Access Compliance Report

Public Rights-of-Way

(Curb Ramps)

Intersection ID: 30075	Main Street: SOUTHWIND_DR	Cross Street: WOODLANDS_POINTE_DR	Location: NW
ADA ID: 5367CFFA5C56	Ramp Type: BlendTrans1	Initial Pass/Fail: Pass	Overall Compliance: No
Severity Score: 10			
Codes/Mitigation Info/Possible Solution		Field Measurements/Component Compliance

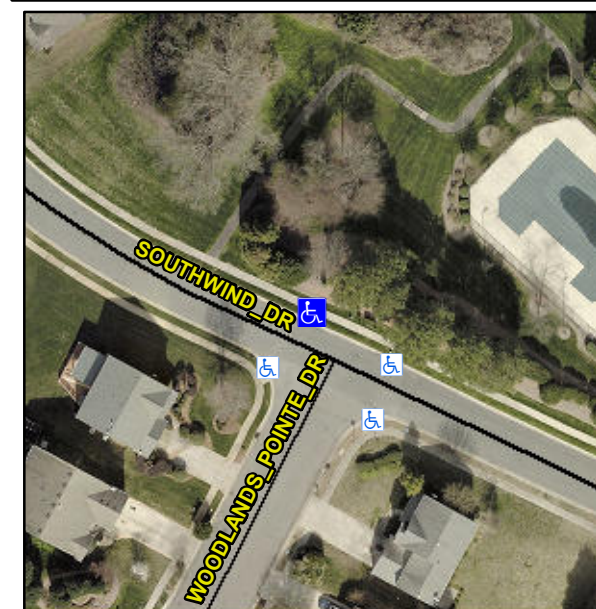
Not Found, R304.2.1, R305

N/A	Ramp inside XWalk1?	N/A	N/A	Ramp inside XWalk2?	N/A
	Road Slope (%)	1.3		Clear Space?	Yes
	Road X Slope (%)	0.9	N/A	Clear Space to XWalk (in)	N/A
Yes	Any Obstructions?	No	Yes	Storm Grate/Utility Hazard?	No
	Obstruction Type			Storm Grate/Utility Type	
		N/A			N/A
			Yes	Surface Condition? (G/P)	Good
			No	Curb Slope (%)	6.3

Remove & Replace Curb Ramp With Two New Directional Ramps or Equivalent.
